MEMORANDUM

TO: All Interested Parties
FROM: Enrique Gonzalez, Staff Liaison
DATE: January 18, 2017
SUBJECT: Proposed TIA (Log No. 002-15) to UNIFORM PLUMBING CODE, Section 205.0 and Section 911.0.

UNIFORM PLUMBING CODE TIA FORM™ - 2015

Reference Code Sections: 205.0 and 911.0

Figure 1 Circuit Vent

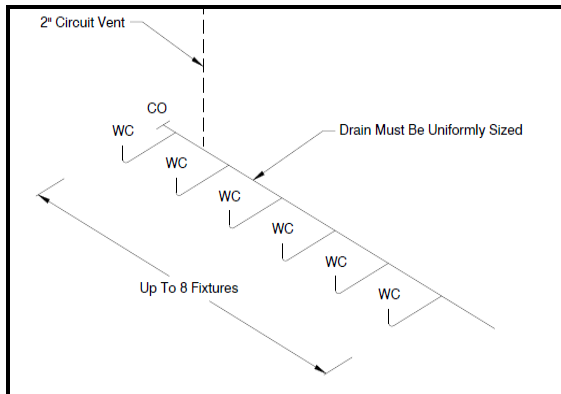
- The figures illustrate the intent of the proposed code language. **Figure 1** displays the basic requirements of where the circuit vent needs to connect to the horizontal branch, the maximum number of fixtures allowed, and the uniform sizing of the horizontal branch. **Figure 2** displays trap arm distance requirements. **Figure 3** illustrates multiple circuit vented branches. On one horizontal branch, the first group of eight fixtures include six water closets and two floor drains. Assuming emergency floor drains with 0 fixture units, the upstream circuit vent is two inches serving the first group of 24 fixture units. The downstream circuit vent is two inches, serving the second group of four water closets and one floor drain having 16 fixture units. Where the two circuit vents connect, Table 703.2 requires the vent size to increase to three inches serving 40 fixture units. **Figure 4** displays the requirement of a relief vent needed when there is a battery of toilets discharging into a stack receiving waste from above.
